**GPI DATA REVIEW
GRAND GULF NUCLEAR STATION
PORT GIBSON, MISSISSIPPI**

PREPARED FOR:
Entergy Operations, Inc.
White Plains, NY

PREPARED BY:
GZA GeoEnvironmental, Inc.
Portland, Maine

April 2009
File No. 09.0025576.00

Figure 2.4.12-204. May 2007 Groundwater Gradient Map, Wells Screened in the Upland Complex

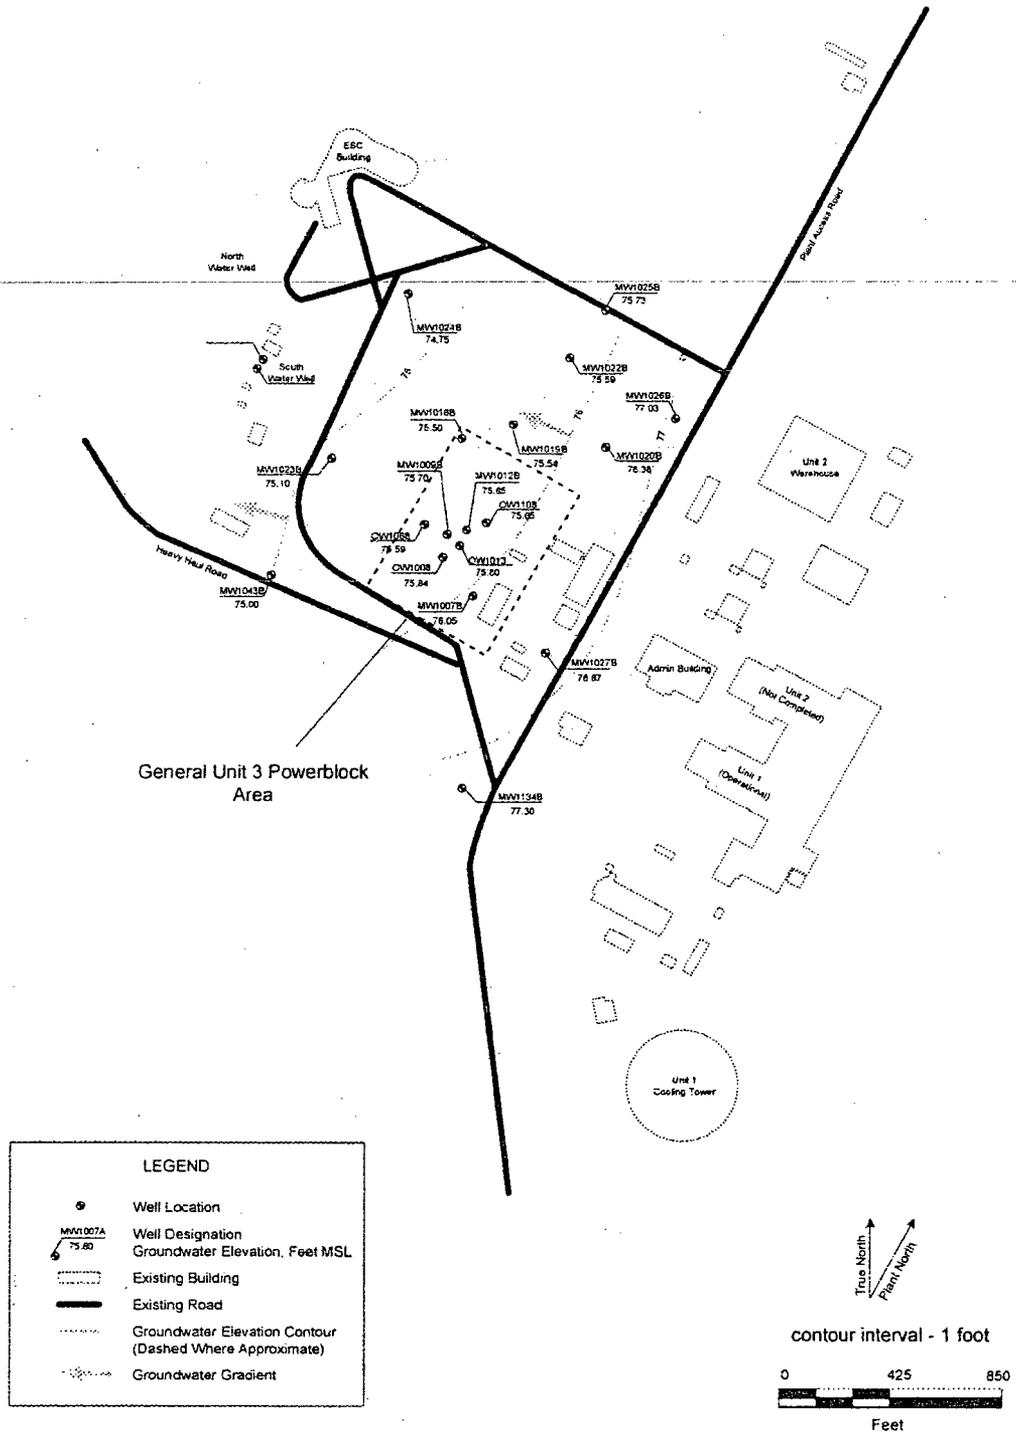
As stated in **Section 3.3**, groundwater contour plans provided in the draft GGNS Unit 3 COLA were based on groundwater level measurements in the Upland Complex wells recorded in December 2006 and May 2007. Copies of these plans are provided in **Appendix C**. For each plan, the groundwater elevation contours depict a groundwater gradient to the west/northwest towards the Mississippi River, consistent with the SCM. The available information also indicates that although an aquitard exists between the Upland Complex and the underlying Catahoula Formation, a downwards vertical hydraulic gradient from the Upland Complex to the Catahoula formation exists.

Although the groundwater contours from the GGNS Unit 3 COLA provide a solid understanding of groundwater gradients west of the existing GGNS plant, they do not show actual gradients and flow directions within the existing plant. In addition, because 1) the closest of these wells to the existing GGNS plant are located approximately 650 feet west of the GGNS plant, 2) that they are spaced 600 to 800 feet apart, and 3) that only one well (MW-1027B) is hydraulically downgradient of the plant, this monitoring well network does not provide adequate groundwater quality monitoring for the existing plant.
